January 11, 1992³
Project 624878

**Subject: Request for Variance from RFI Work Plan,
Regarding Monitoring Well Dimensions**

BURLINGTON PIER 91 FACILITY
TYPICAL DEEP AQUIFER
MONITORING WELL COMPLETION

FIGURE C-4

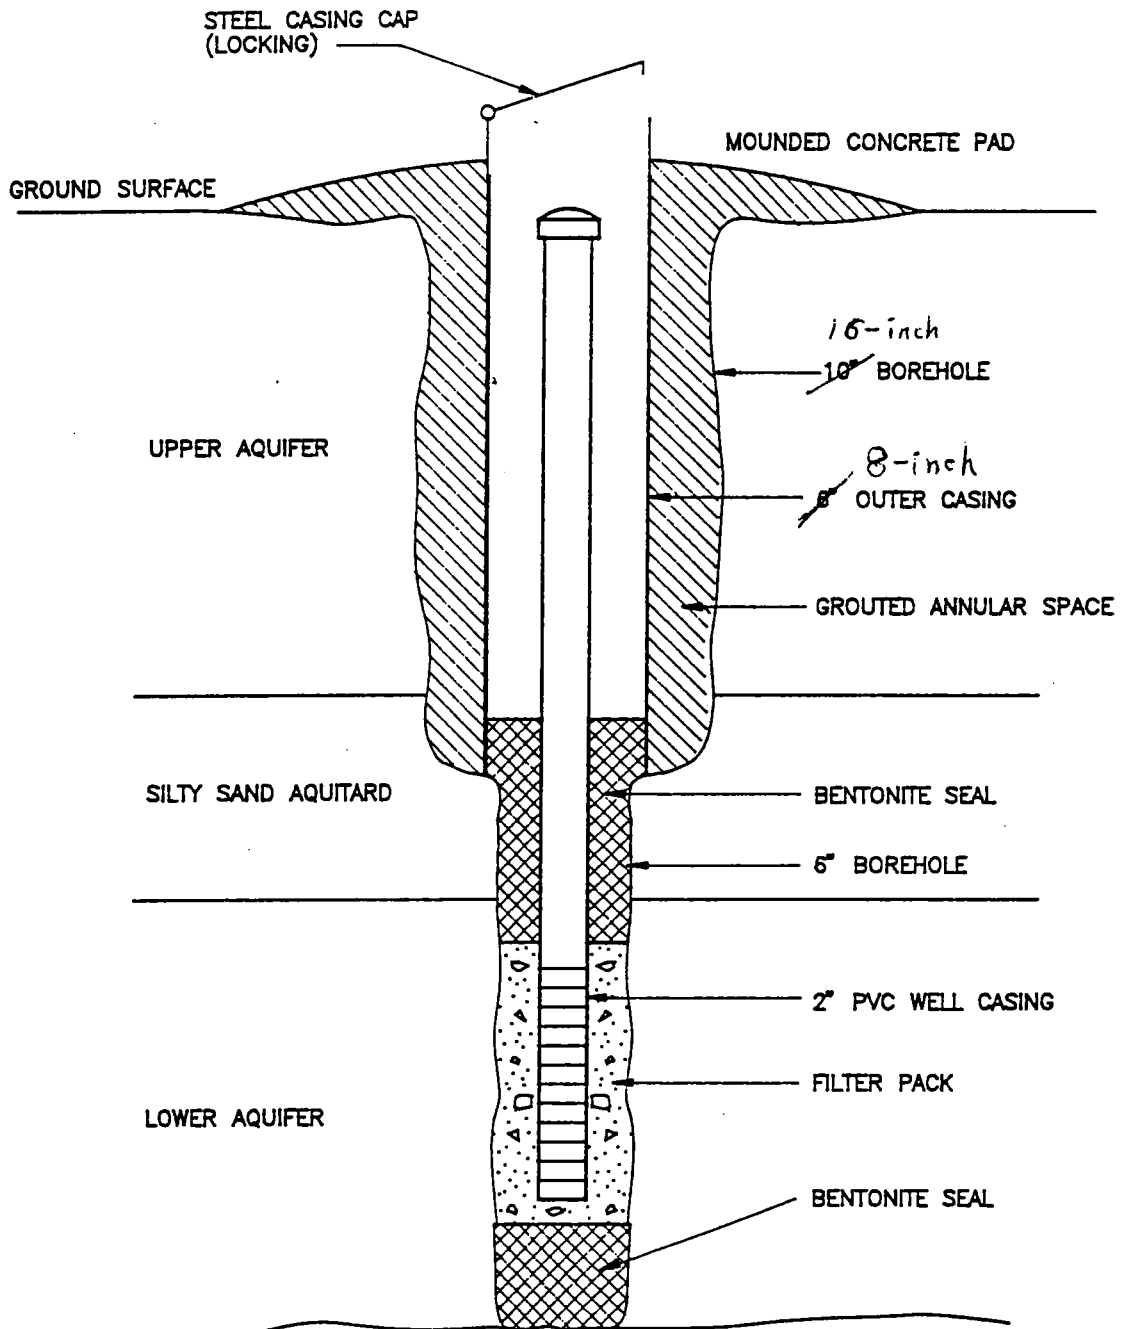
This letter is to clarify the details of the variance request we agreed to in our telephone conversation on January 8, 1992.³ Approval is requested for the following modifications of the Burlington Environmental Inc. Pier 91 RFI Work Plan. These modifications involve the dimensions of proposed deep-aquifer monitoring wells CP-106B and CP-115B only.

The modifications are as follows. First, the inside diameter (i.d.) of the outer (permanent) casing will be changed from six inches to eight inches. Second, the nominal borehole diameter will be changed from 10 inches to 16 inches.

The lower portion of the borehole is to be advanced by the cable tool method. This involves driving a temporary casing, and installing the well through the temporary casing as the casing is extracted. Washington state law requires that the borehole for a two-inch monitoring well have a minimum diameter of six inches. Therefore the minimum nominal diameter of the temporary casing is approximately six inches. Clearly the outer (permanent) casing must have a diameter greater than six inches so that it can accommodate the temporary casing during well installation.

The upper portion of the borehole is to be advanced using a hollow stem auger drill. The permanent casing is to be emplaced through the auger, while the auger is in the borehole. In order to accommodate the permanent casing, the inside diameter of the auger must be greater than the outside diameter of the permanent casing, which is approximately 8.5 inches. A 16-inch outside-diameter auger, with inside diameter of approximately 11 inches, should be sufficient.

A photocopy of Figure C-4 from the RFI Work Plan, modified as per the two changes described above, is attached for your convenience. I would appreciate your prompt response to this request.
